UNITED STATES PATENT AND TRADEMARK OFFICE

APPLICATION NO.	FILING DATE	FIRST NAMED INVENTOR	ATTORNEY DOCKET NO.	CONFIRMATION NO.
10/780,999	02/18/2004	John A. Johansen	2065.002300	2417
23720	7590	06/06/2005	EXAMINER	
WILLIAMS, MORGAN & AMERSON, P.C. 10333 RICHMOND, SUITE 1100 HOUSTON, TX 77042			WAKS, JOSEPH	
			ART UNIT	PAPER NUMBER
			2834

Office Action Summary	Application No. 10/780,999	Applicant(s) JOHANSEN ET AL.	
	Examiner Joseph Waks	Art Unit 2834

FIG. 1

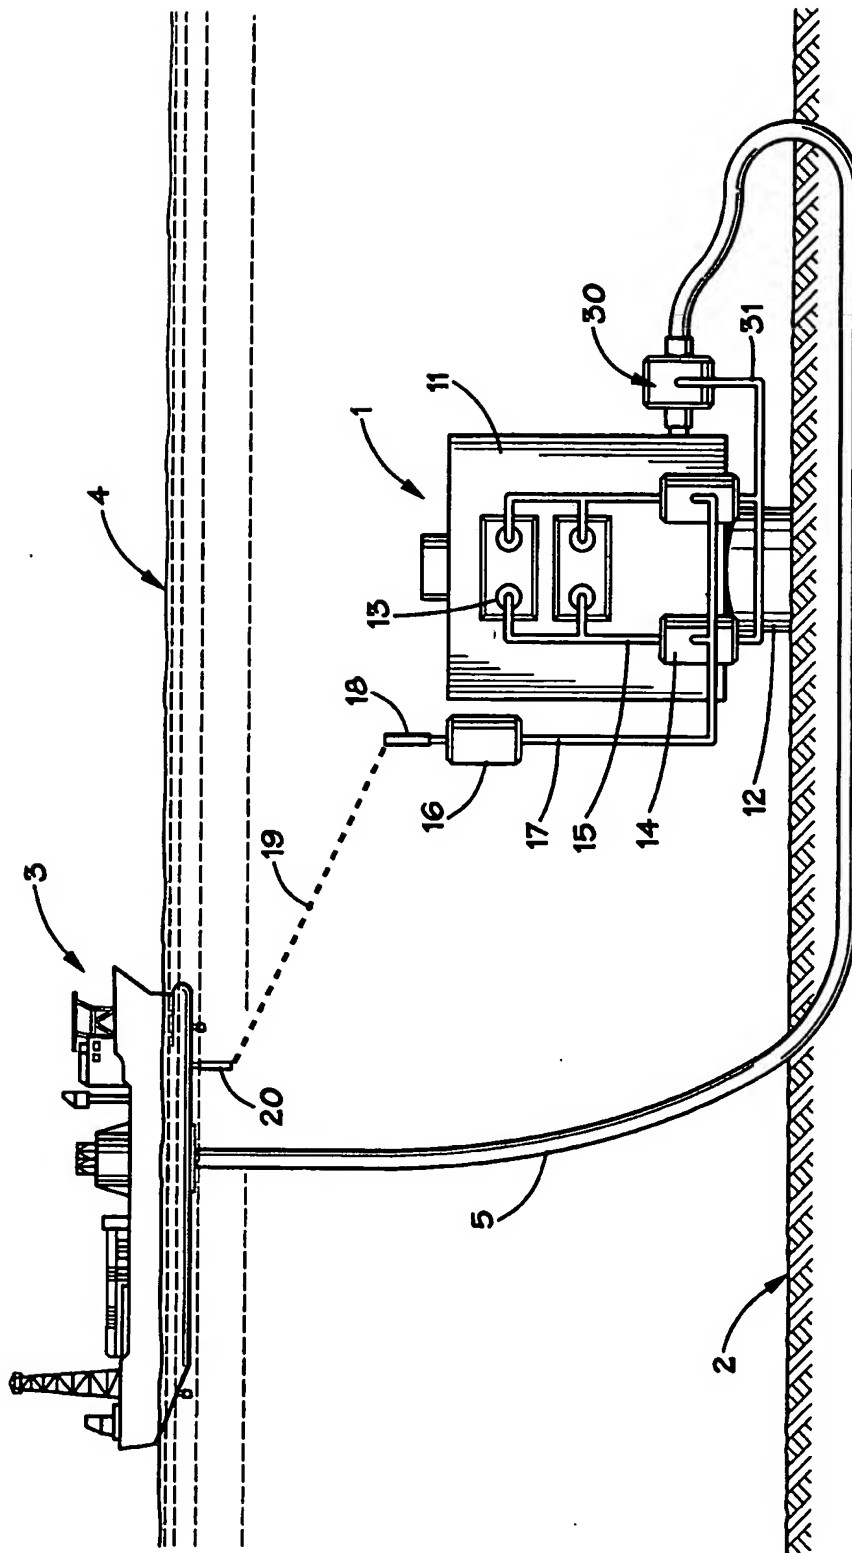
Not approved
JW 5/25/05

FIG. 2

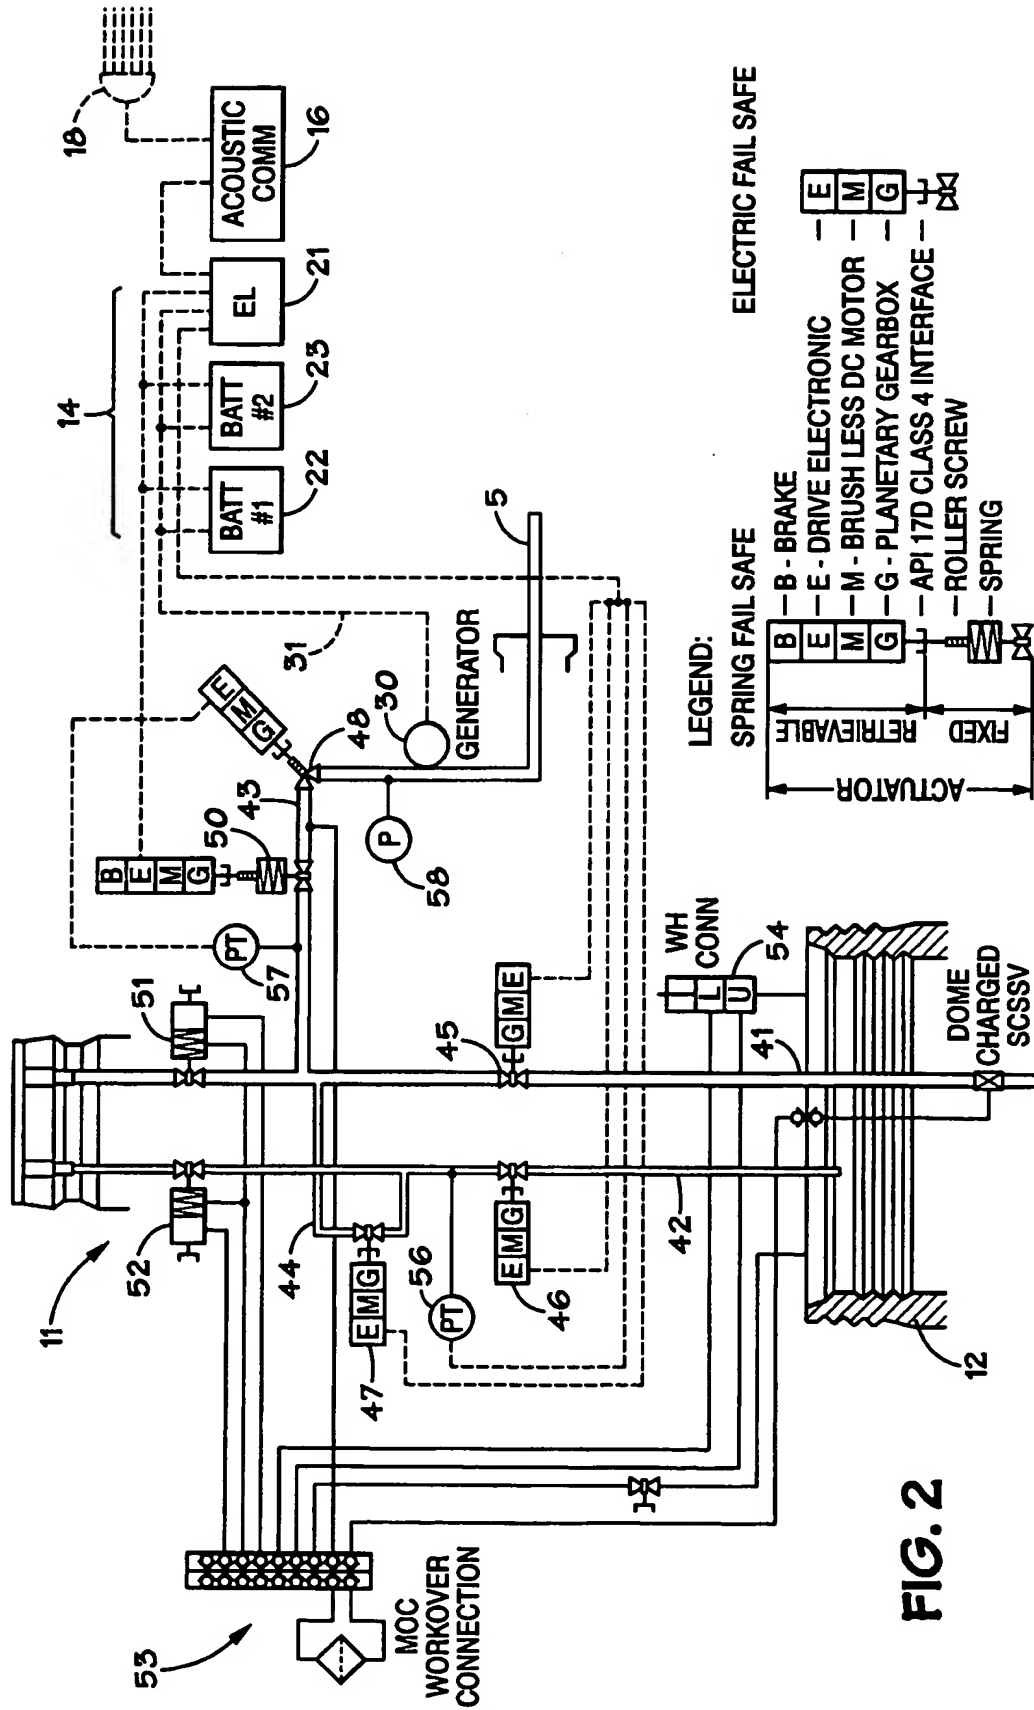
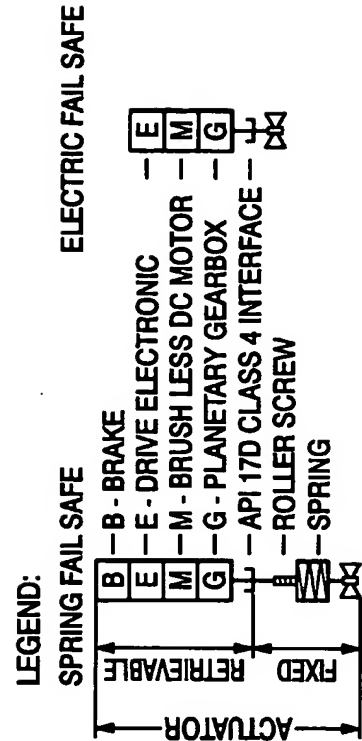
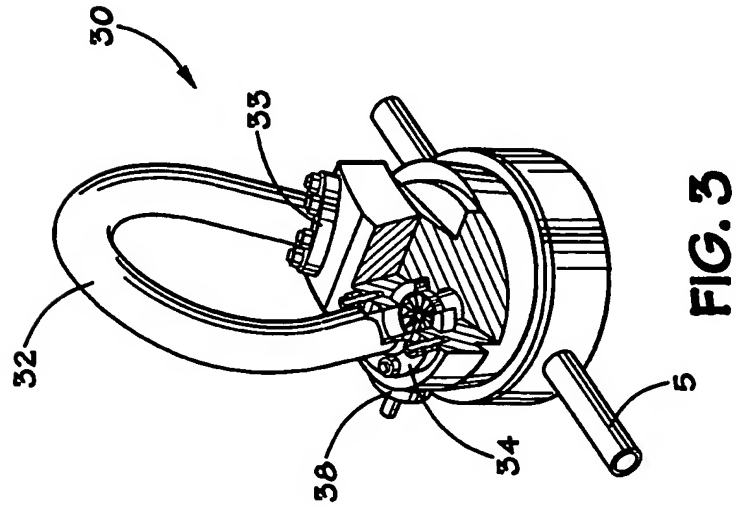
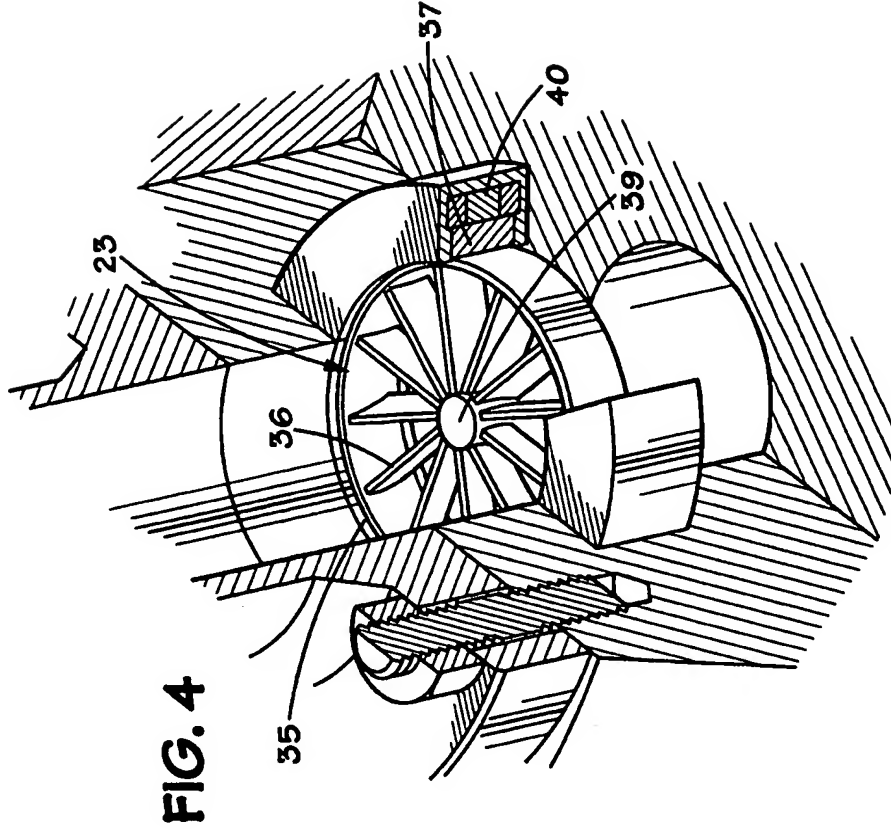
Not approved
5/25/05 JW

Not approved
5/25/05 Jw

FIG. 5

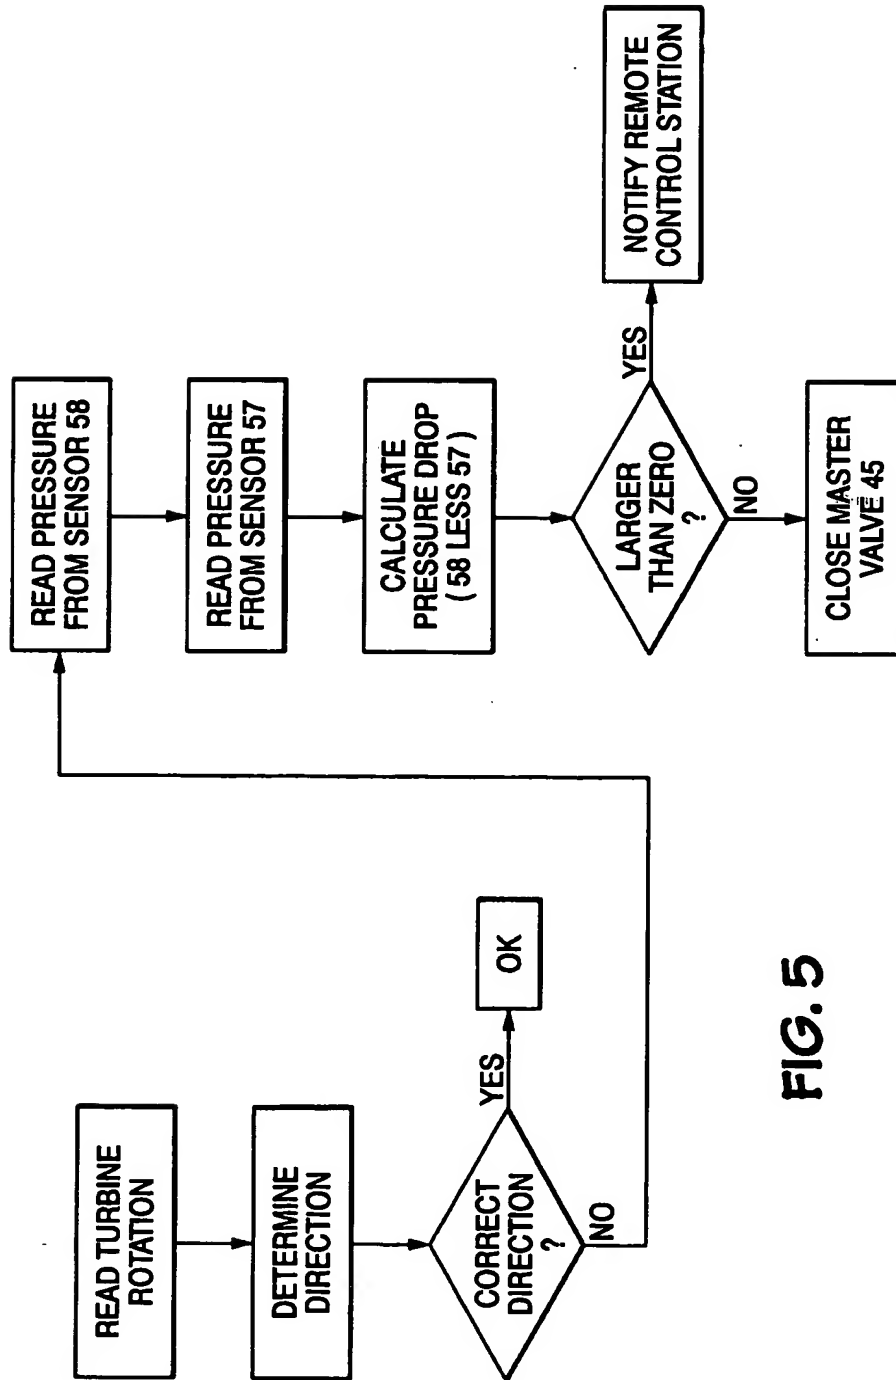
Not approved
5/25/05 JW
